| CONTRACT NO. 66294  |             |                           |                 |              |

| SUMMARY OF QUANTITIES |                                                          |       |            | CONSTRUCTION TYPE CODE |                     |                      |                     |                      |                     |

REVISED  
4-11-2006  
PER ADDENDUM

ILLINOIS DEPARTMENT OF TRANSPORTATION  
FAI ROUTE 80 (I-80 AT MINOOKA INTERCHANGE)

ILLINOIS DEPARTMENT OF TRANSPORTATION  
FAI ROUTE 80 (I-80 AT MINOOKA INTERCHANGE)  
TEMPORARY LIGHTING  
RAMP "A" AND RAMP "C"  
SHEET 1 OF 2  
PRE-STAGE  
SCALE: 1:50  
DATE: 12/9/2005  
DRAWN BY: KGP/MAE  
CHECKED BY: MAE/PKG

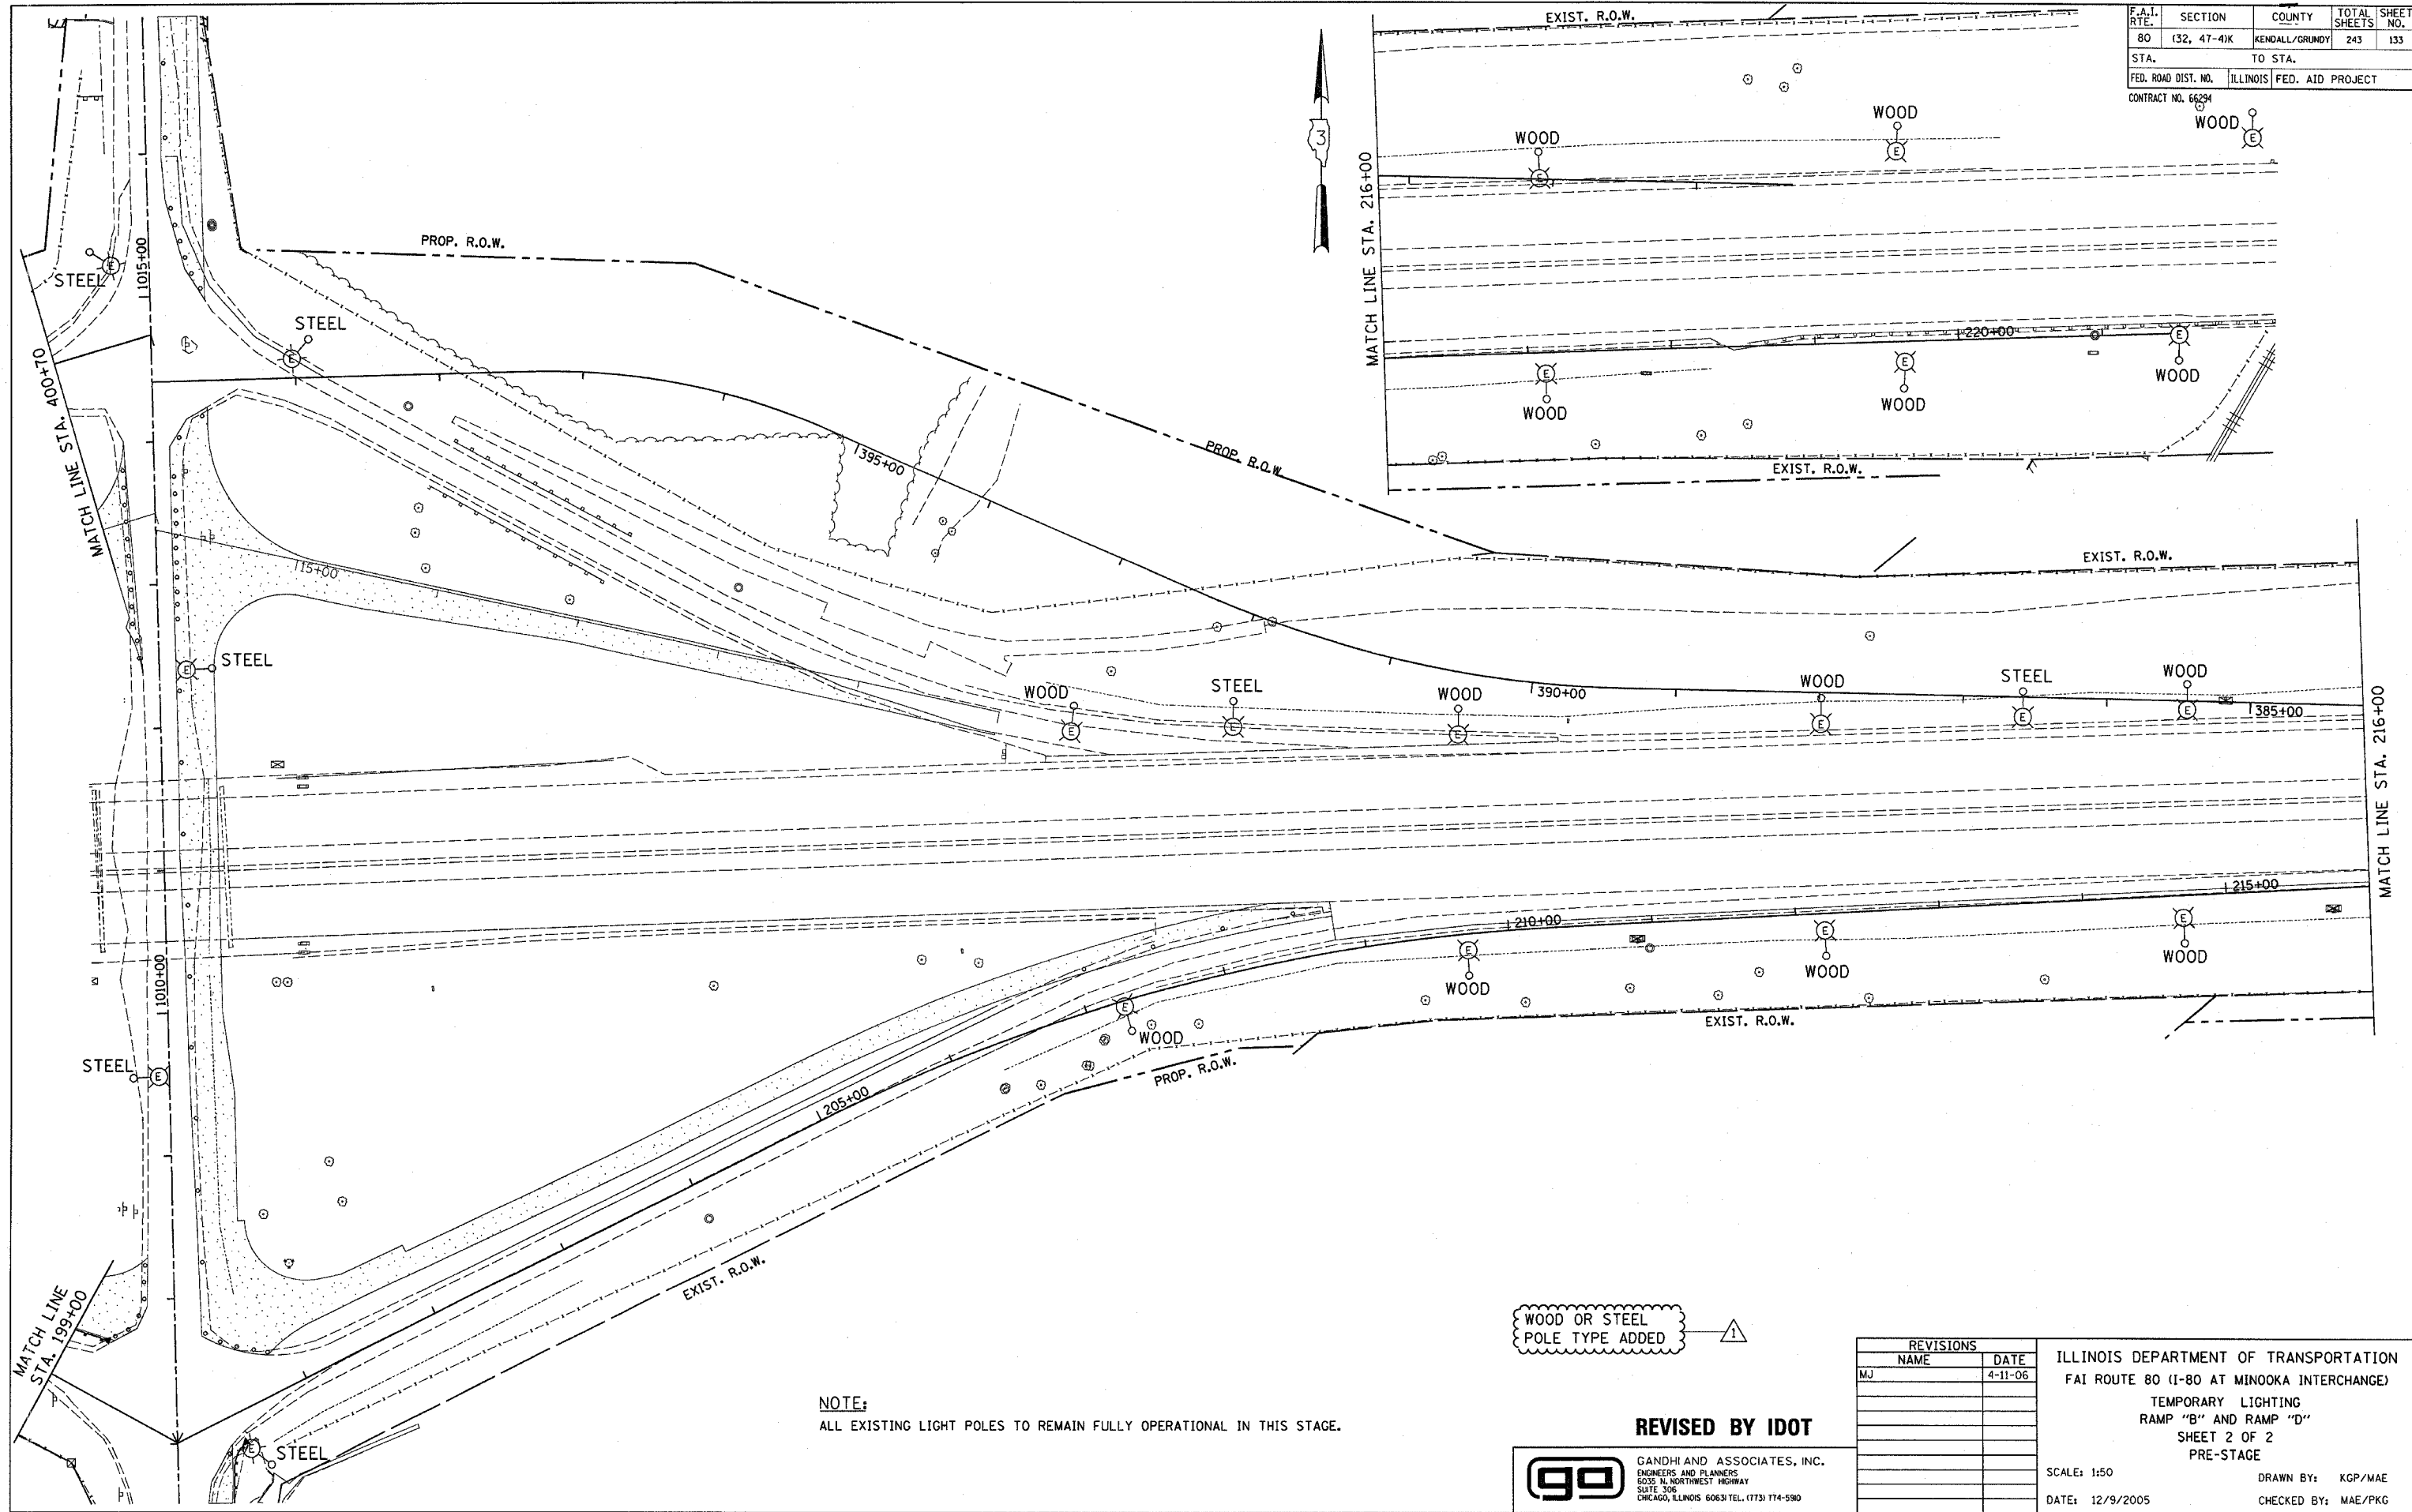
WOOD OR STEEL  
POLE TYPE ADDED

ILLINOIS DEPARTMENT OF TRANSPORTATION  
FAI ROUTE 80 (I-80 AT MINOOKA INTERCHANGE)  
TEMPORARY LIGHTING  
RAMP "B" AND RAMP "D"  
SHEET 2 OF 2  
PRE-STAGE

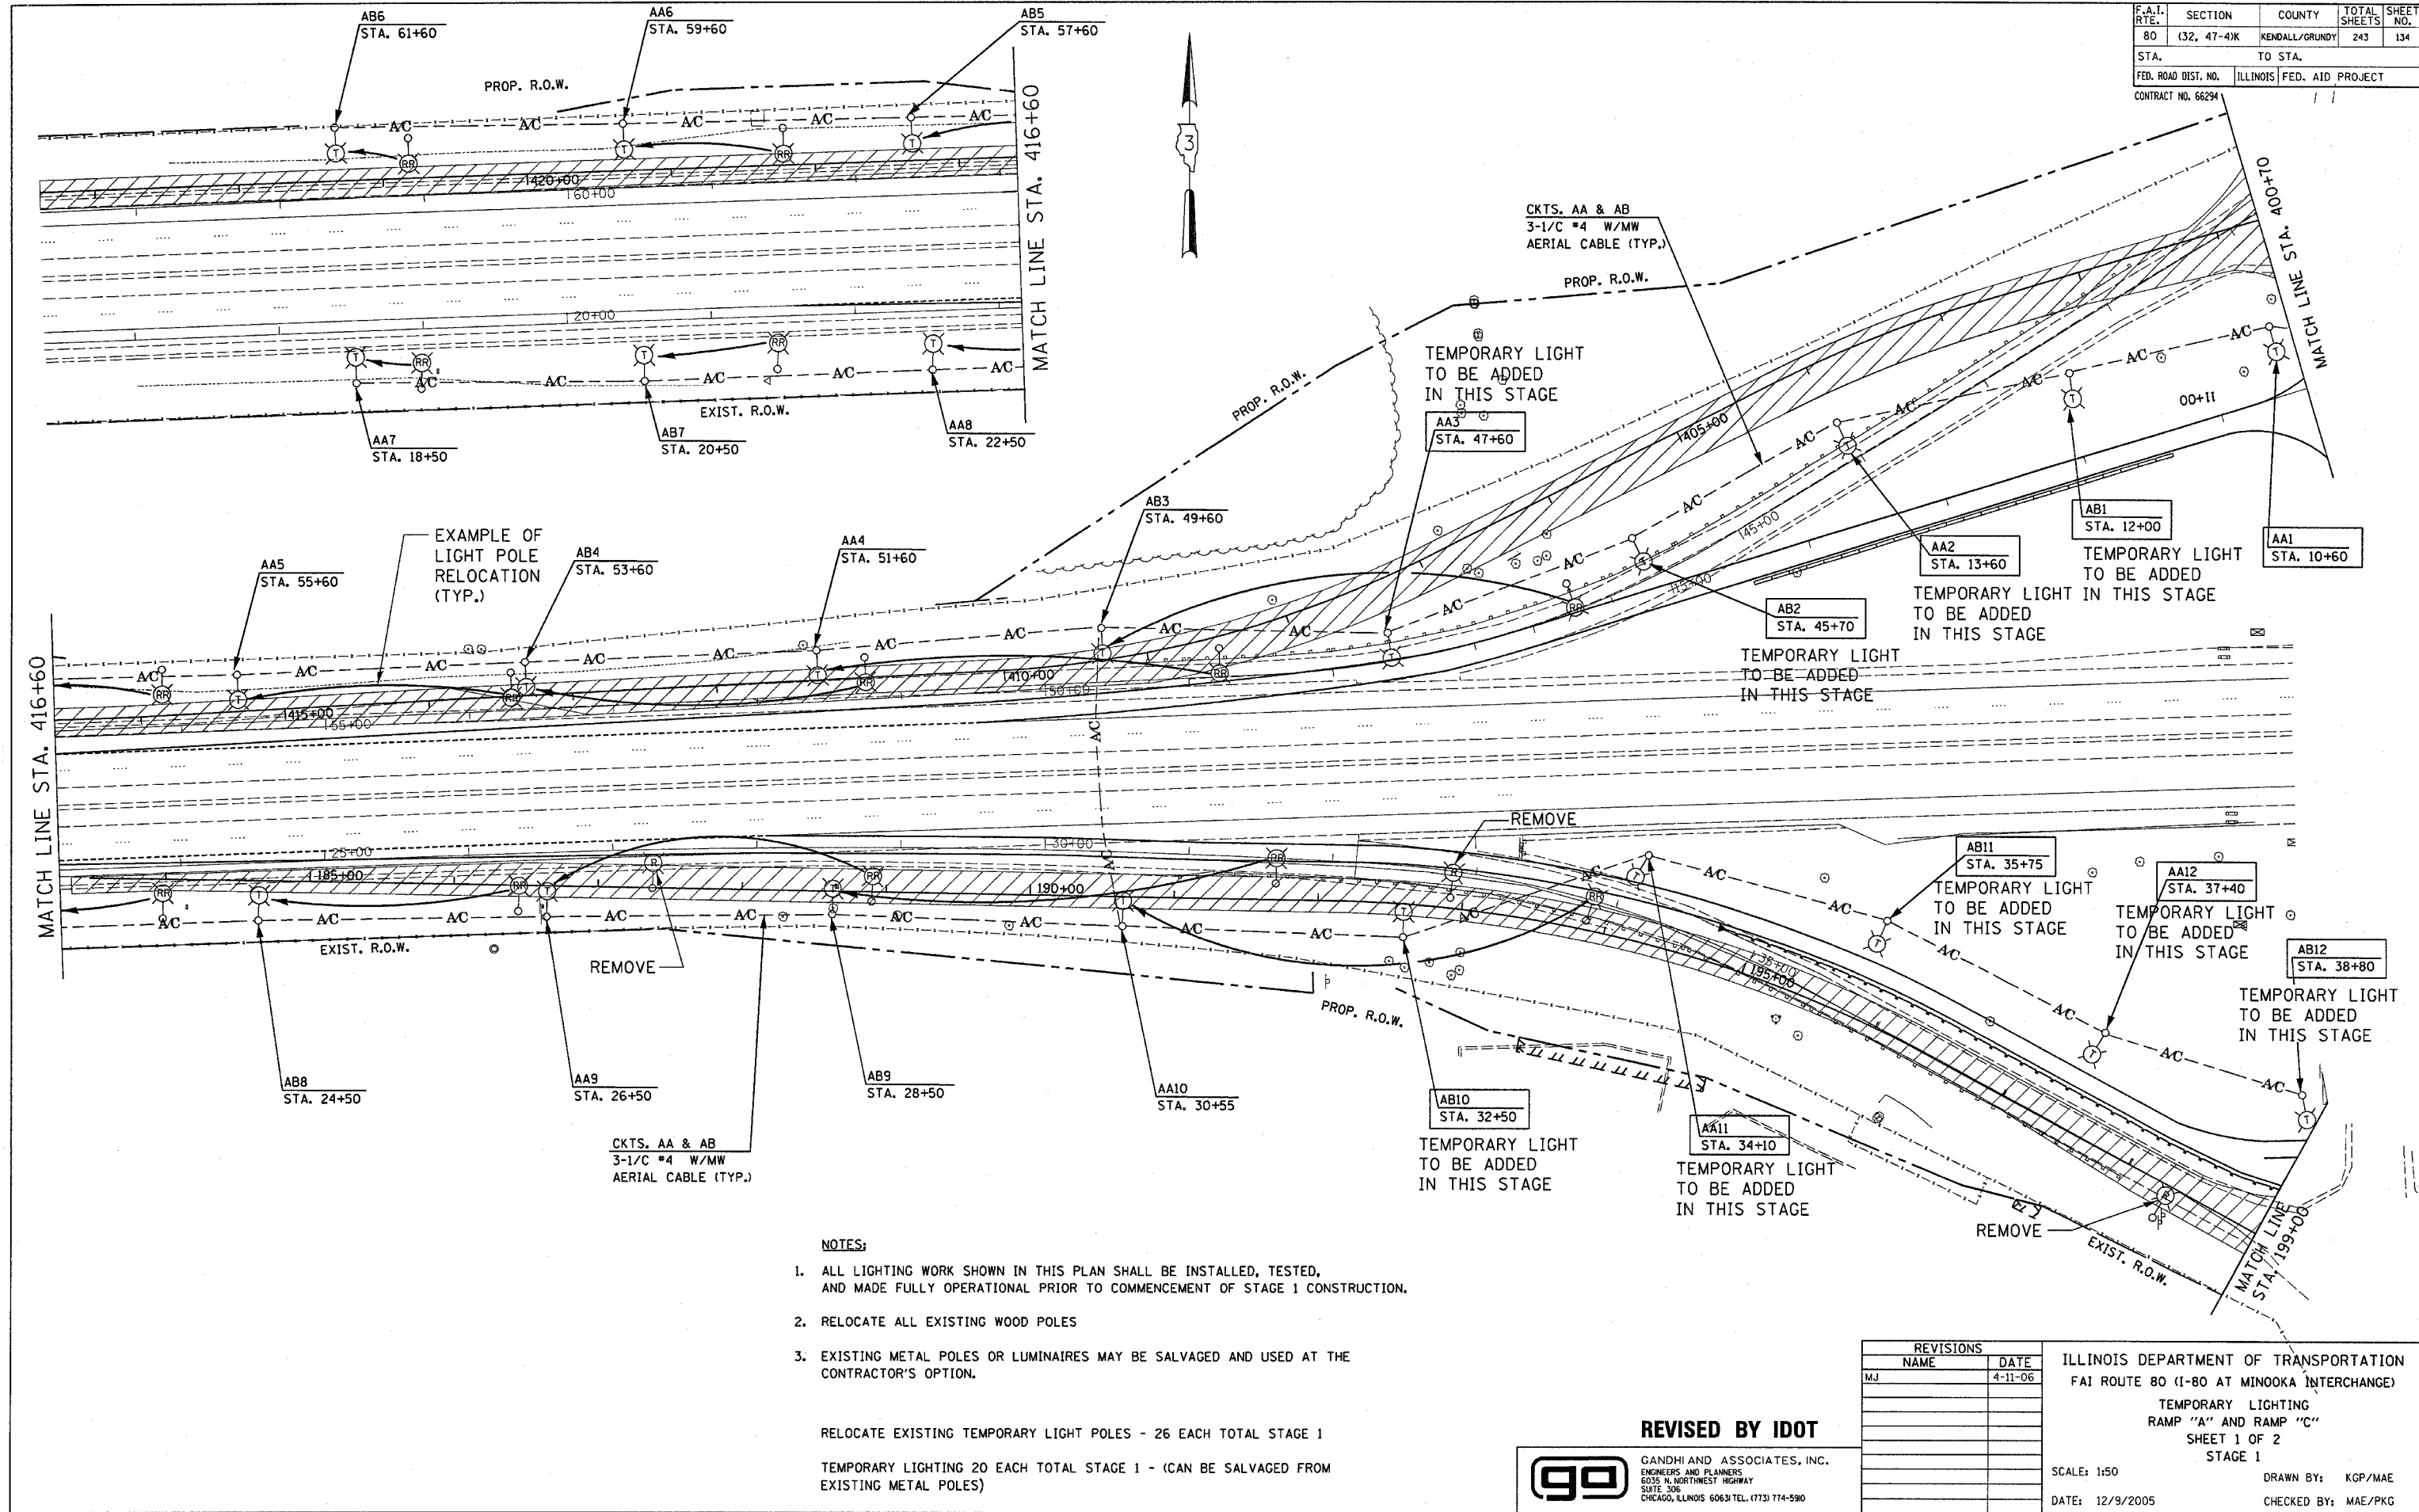
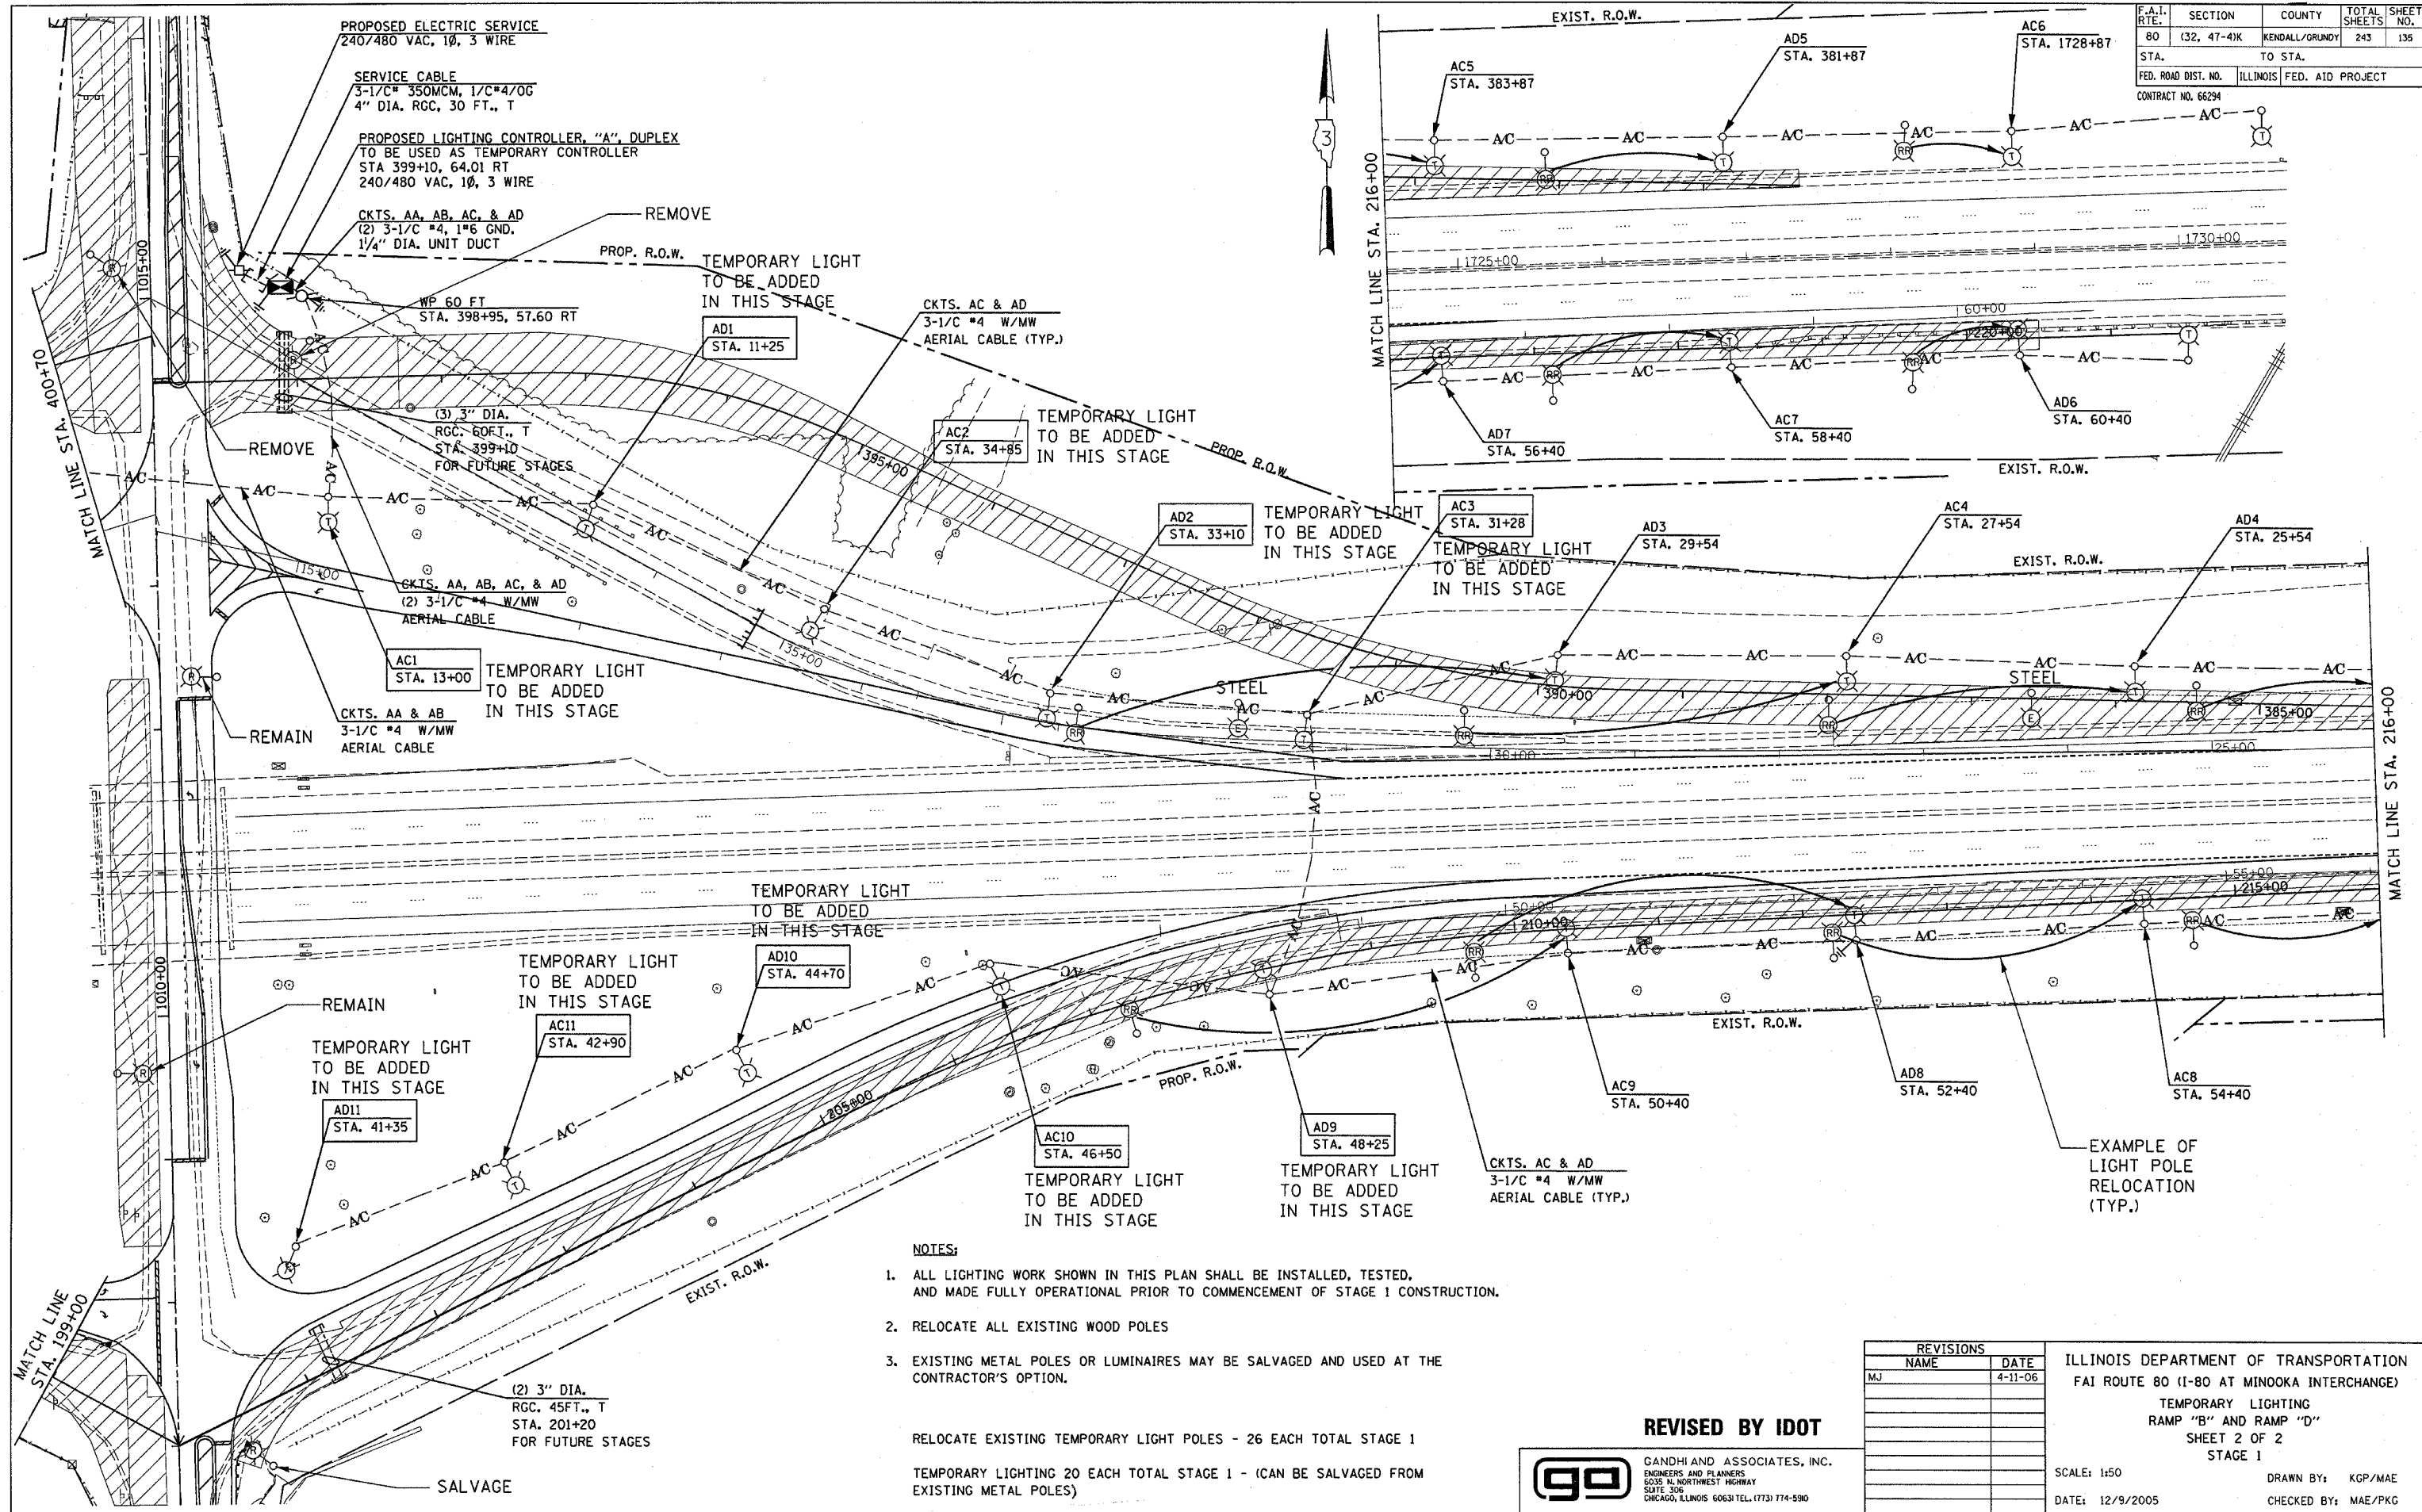
WOOD OR STEEL  
POLE TYPE ADDED
